Letter of Intent

Re: **Meridian Storage Site Development Plan**

PPR23-xxx

Figure 3-2 Drainage Basin Map Falcon DBPS El Paso County, CO

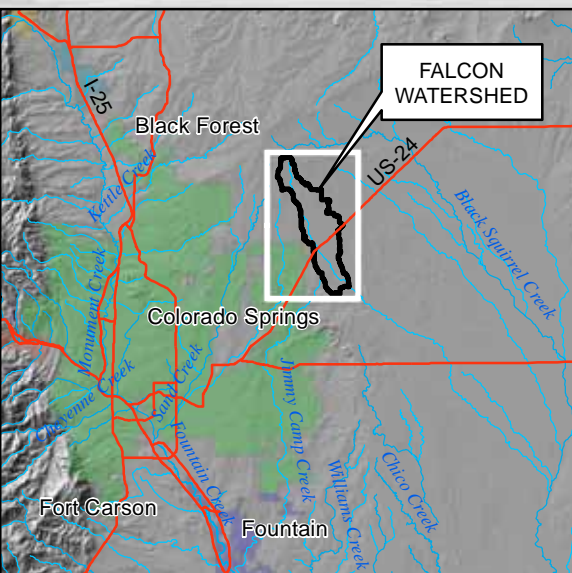
Fix figure - entire background show up as black making the figure difficult to read.

DETENTION BASIN STAGE-STORAGE TABLE BUILDER

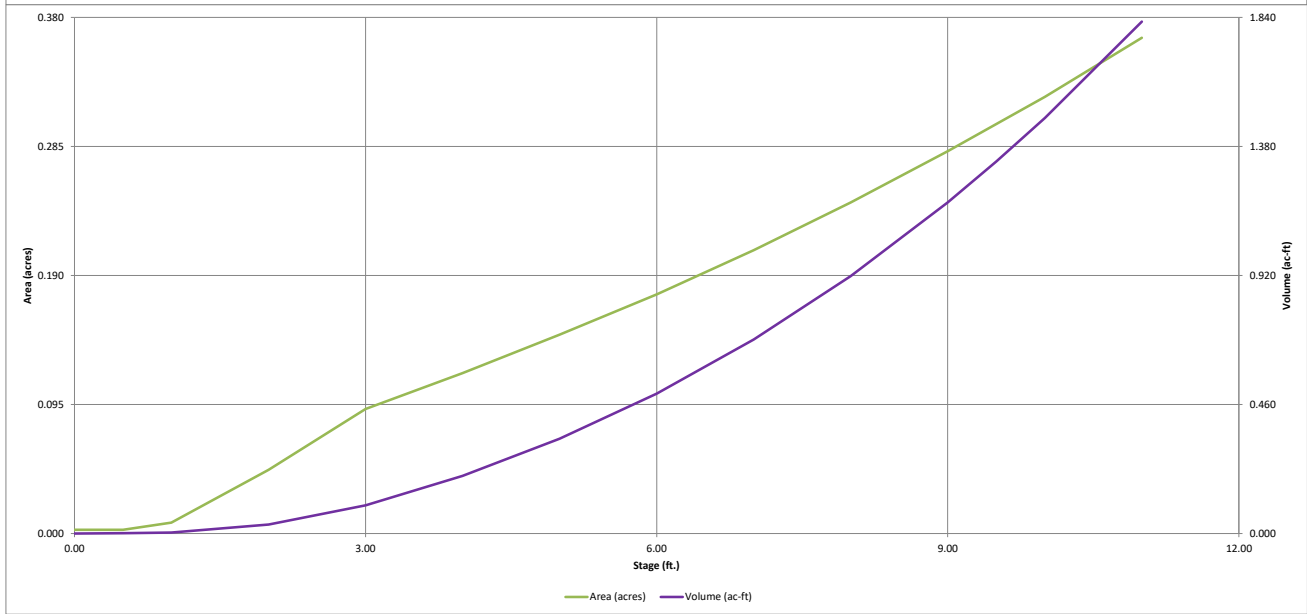
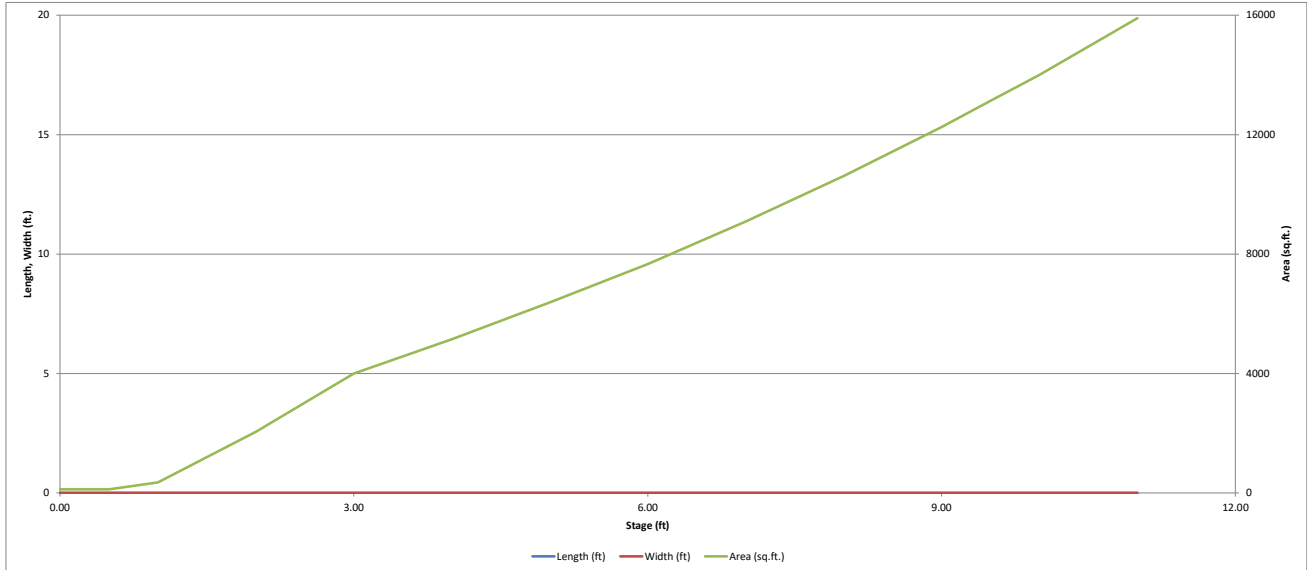
Provide pond details for updated pond design and see VR239 comments on the spreadsheet. This spreadsheet will be reviewed once updated pond details are provided.
